⌘ **25.213** **CR 040** ⌘ ev **-** ⌘ Current version: **3.5.0** ⌘

Title:	⌘ Clarification of DL channelization code alignment		
Source:	⌘ Panasonic, QUALCOMM Europe		
Work item code:	⌘	Date:	⌘ 15, May, 2001
Category:	⌘ F	Release:	⌘ R99
	Use <u>one</u> of the following categories: F (correction) A (corresponds to a correction in an earlier release) B (addition of feature), C (functional modification of feature) D (editorial modification) Detailed explanations of the above categories can be found in 3GPP TR 21.900 .		Use <u>one</u> of the following releases: 2 (GSM Phase 2) R96 (Release 1996) R97 (Release 1997) R98 (Release 1998) R99 (Release 1999) REL-4 (Release 4) REL-5 (Release 5)

R1-01-0496

CR-Form-v4
CHANGE REQUEST
⌘ 25.213 CR 041 ⌘ ev - ⌘ Current version: 4.0.0 ⌘

Figure 8: Spreading for all downlink physical channels except SCH

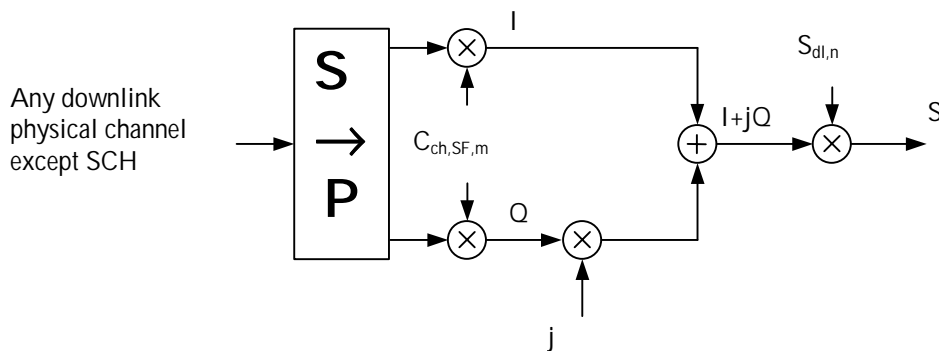
Reason for change:	⌘ The channelization code sequence is aligned to symbol boundary is not well described.
Summary of change:	⌘ To add following text: The channelization code sequence should be aligned in time with the symbol boundary.
Consequences if not approved:	⌘ Misunderstanding may happen to the channelization code phase.

Each pair of two consecutive symbols is first serial-to-parallel converted and mapped to an I and Q branch. The mapping is such that even and odd numbered symbols are mapped to the I and Q branch respectively. For all channels except AICH, symbol number zero is defined as the first symbol in each frame. For AICH, symbol number zero is defined as the first symbol in each access slot. The I and Q branches are then spread to the chip rate by the same real-valued channelization code $C_{ch,SF,m}$. The channelization code sequence should be aligned in time with the symbol boundary. The sequences of real-valued chips on the I and Q branch are then treated as a single complex-valued sequence of chips. This sequence of chips is scrambled (complex chip-wise multiplication) by a complex-valued scrambling code $S_{dl,n}$. In case of P-CCPCH, the scrambling code is applied aligned with the P-CCPCH frame boundary, i.e. the first complex chip of the spread P-CCPCH frame is multiplied with chip number zero of the scrambling code. In case of other downlink channels, the scrambling code is applied aligned with the scrambling code applied to the P-CCPCH. In this case, the scrambling code is thus not necessarily applied aligned with the frame boundary of the physical channel to be scrambled.

Figure 8: Spreading for all downlink physical channels except SCH

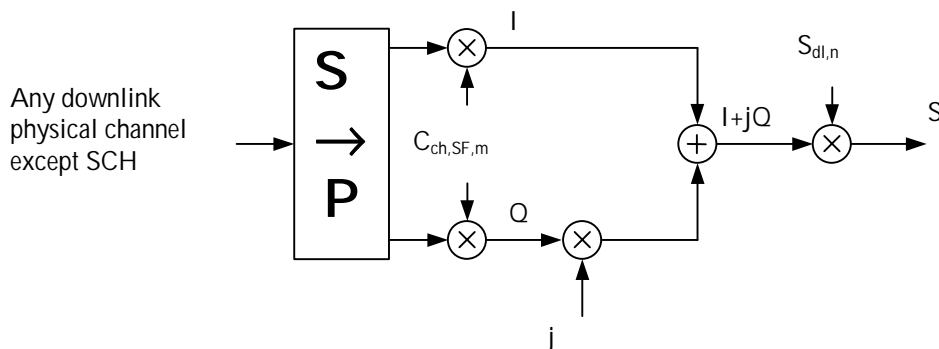
Reason for change:	⌘ The channelization code sequence is aligned to symbol boundary is not well described.
Summary of change:	⌘ To add following text: The channelization code sequence should be aligned in time with the symbol boundary.
Consequences if not approved:	⌘ Misunderstanding may happen to the channelization code phase.

Each pair of two consecutive symbols is first serial-to-parallel converted and mapped to an I and Q branch. The mapping is such that even and odd numbered symbols are mapped to the I and Q branch respectively. For all channels except AICH, symbol number zero is defined as the first symbol in each frame. For AICH, symbol number zero is defined as the first symbol in each access slot. The I and Q branches are then spread to the chip rate by the same real-valued channelization code $C_{ch,SF,m}$. The channelization code sequence should be aligned in time with the symbol boundary. The sequences of real-valued chips on the I and Q branch are then treated as a single complex-valued sequence of chips. This sequence of chips is scrambled (complex chip-wise multiplication) by a complex-valued scrambling code $S_{dl,n}$. In case of P-CCPCH, the scrambling code is applied aligned with the P-CCPCH frame boundary, i.e. the first complex chip of the spread P-CCPCH frame is multiplied with chip number zero of the scrambling code. In case of other downlink channels, the scrambling code is applied aligned with the scrambling code applied to the P-CCPCH. In this case, the scrambling code is thus not necessarily applied aligned with the frame boundary of the physical channel to be scrambled.
